AMENDMENT C CHANGES. SHOWN CLOUDED.

VIEW FROM FISHERMANS BEACH UPDATED WITH NE PROPOSAL.  
DRAWING REGISTER UPDATED.

41 & 43 BEACH ROAD COLLAROY  
LO1 1 DP300846 AND LOT 2 SEC 7 DP7391

COVER + PHOTOMONTAGES

DRAWING TITLE ANALYSIS OF PROPOSAL - 3D IMAGES AGAINST DCP B3 "SIDE BOUNDARY ENVELOPE" CONTROL	SCALE: N/A	DRAWING NO. DA 106-C

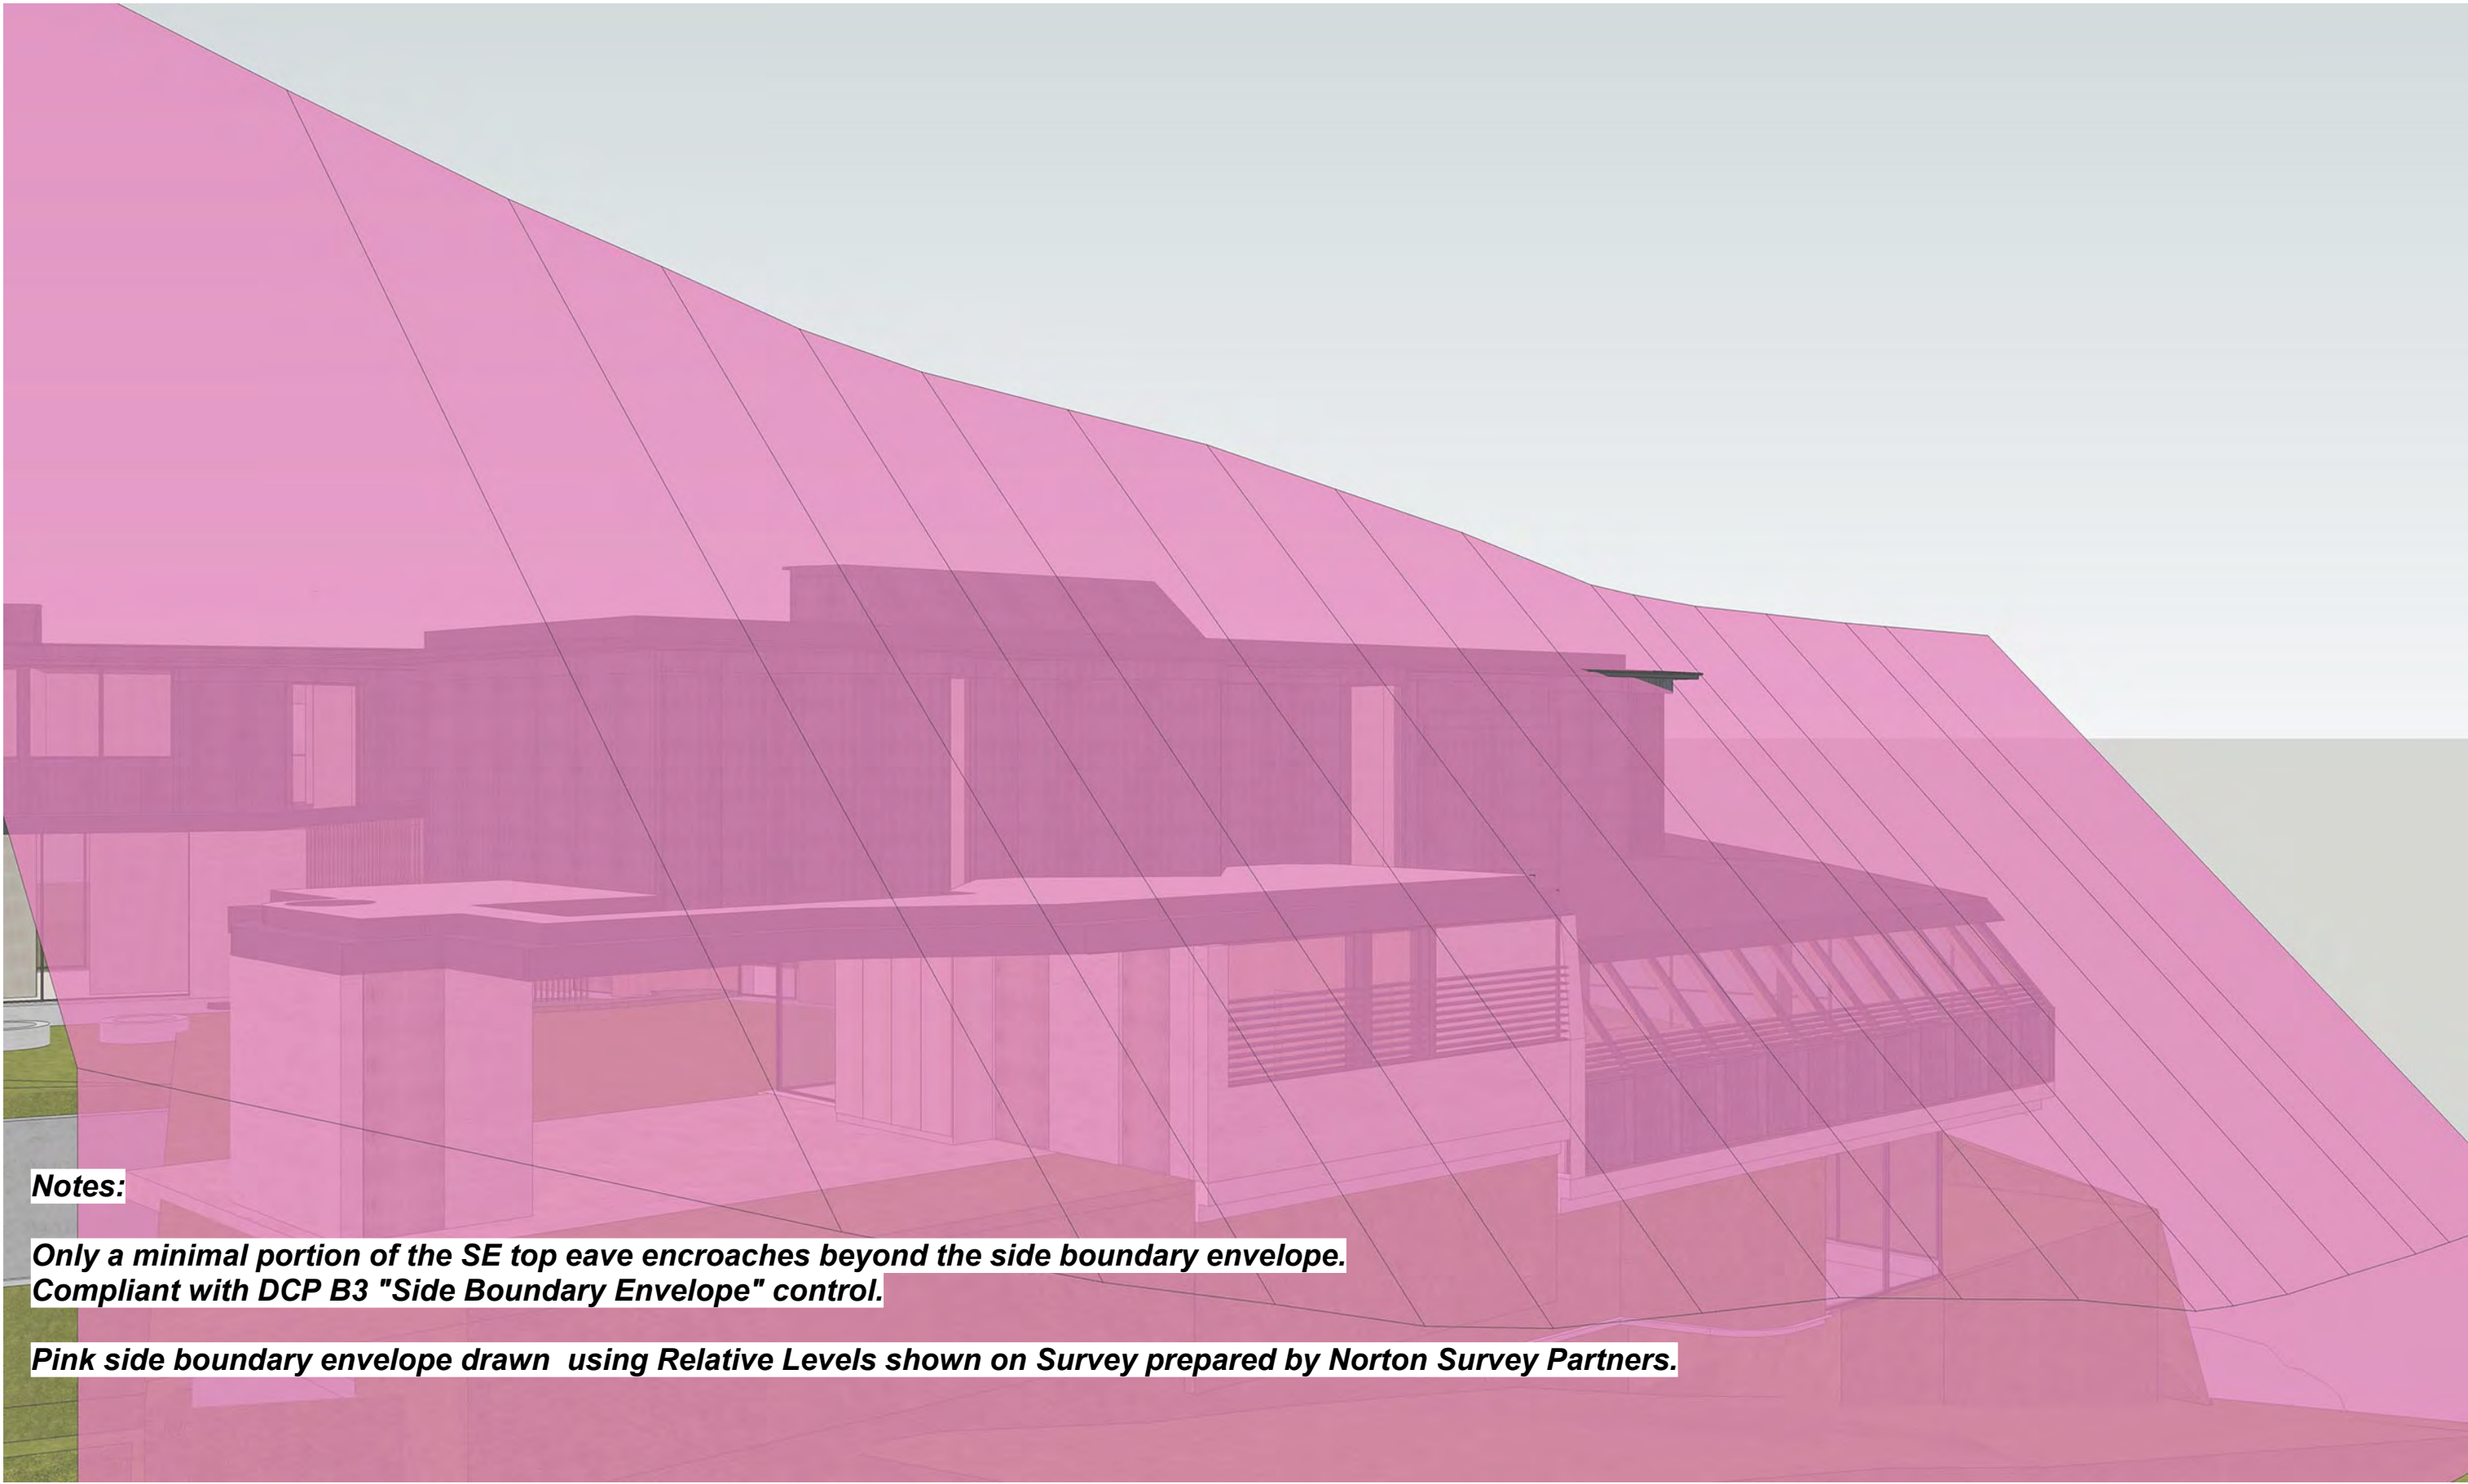
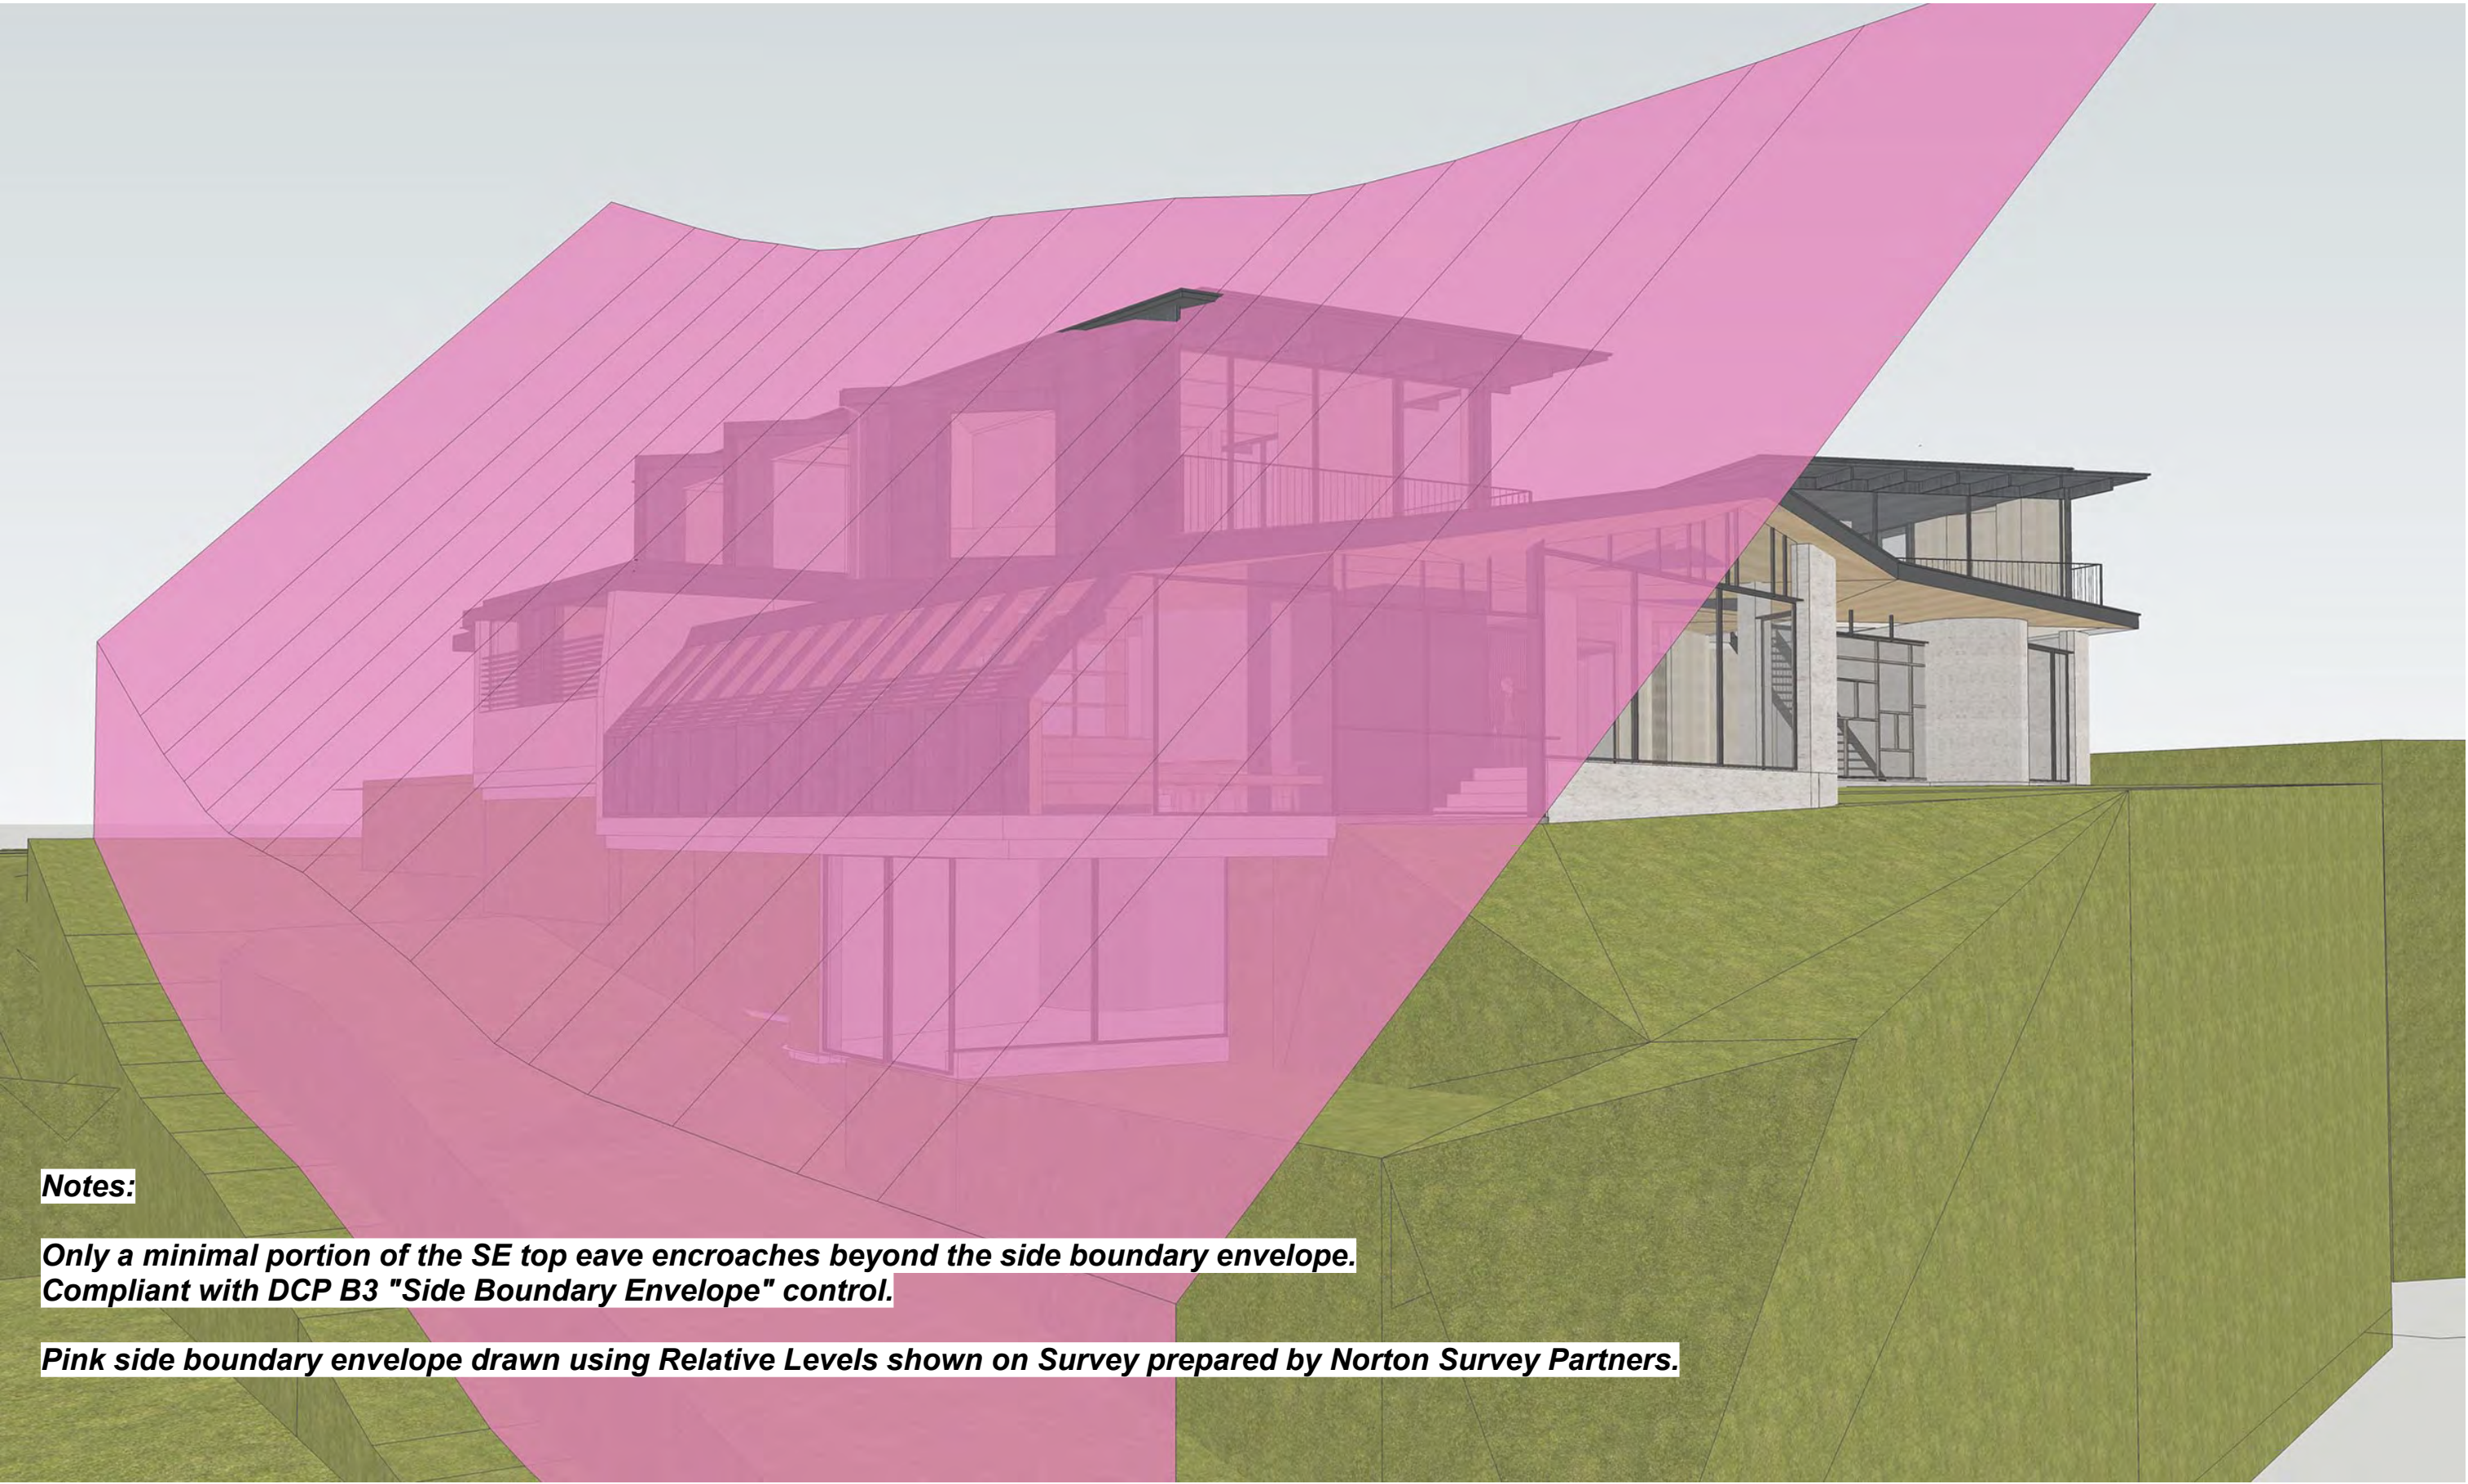
**Only a minimal portion of the SE top eave encroaches beyond the side boundary envelope. Compliant with DCP B3 "Side Boundary Envelope" control.**

3D image of Amendment "D" proposal. Prepared by VK.  
Assessed against DCP B3 "Side Boundary Envelope" control.
